DEVELOPMENT APPLICATION ASSESSMENT REPORT

Application Number:	DA2024/0831		
Responsible Officer:	Lachlan Rose		
Land to be developed (Address):	Lot 3 DP 6210, 50 Macmillan Street SEAFORTH NSW 2092		
Proposed Development:	Alterations and additions to a detached garage		
Zoning:	Manly LEP2013 - Land zoned R2 Low Density Residential		
Development Permissible:	Yes		
Existing Use Rights:	No		
Consent Authority:	Northern Beaches Council		
Land and Environment Court Action:	No		
Applicant:	Lloyd Anthony Weir		
Application Lodged:	12/07/2024		
Integrated Development:	No		
Designated Development:	No		
State Reporting Category:	Residential - Alterations and additions		
Notified:	29/07/2024 to 12/08/2024		
Advertised:	Not Advertised		
Submissions Received:	2		
Clause 4.6 Variation:	Nil		
Recommendation:	Approval		
Estimated Cost of Works:	\$ 74,496.00

Figure 1: Shadow diagrams

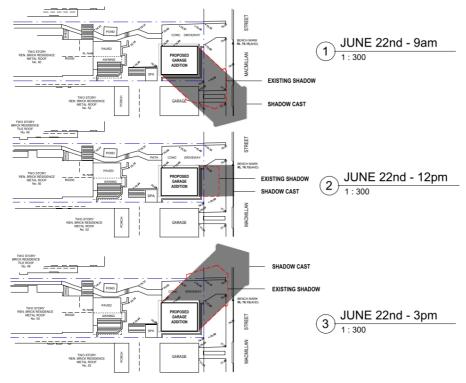
Clause 3.4.1.1 Overshadowing Adjoining Open Space stipulates that new development must not eliminate more than one third of the existing sunlight accessing the private open space of adjacent properties from 9am to 3pm at the winter solstice (21 June).

The submitted shadow diagrams (see figure 1 below) depict that the proposal will result in a net increase in solar access to the private open space of 52 and 48 Macmillan Street. The additional overshadowing is to the rear pool area of 48 Macmillan Street with impacts at 12pm to 3pm. However, the proposal will result in no additional overshadowing impacts to 18 Condamine Street from 9am to 12pm. The overshadowing impacts are prevalent to 52 Macmillan from 9m- 12pm, with no additional impacts after 12pm. Notwithstanding the above overshadowing impacts, the proposal will not eliminate more than one third of the existing sunlight access to the private open space of adjacent properties from 9am to 3pm and is considered satisfactory to the requirements of this control.
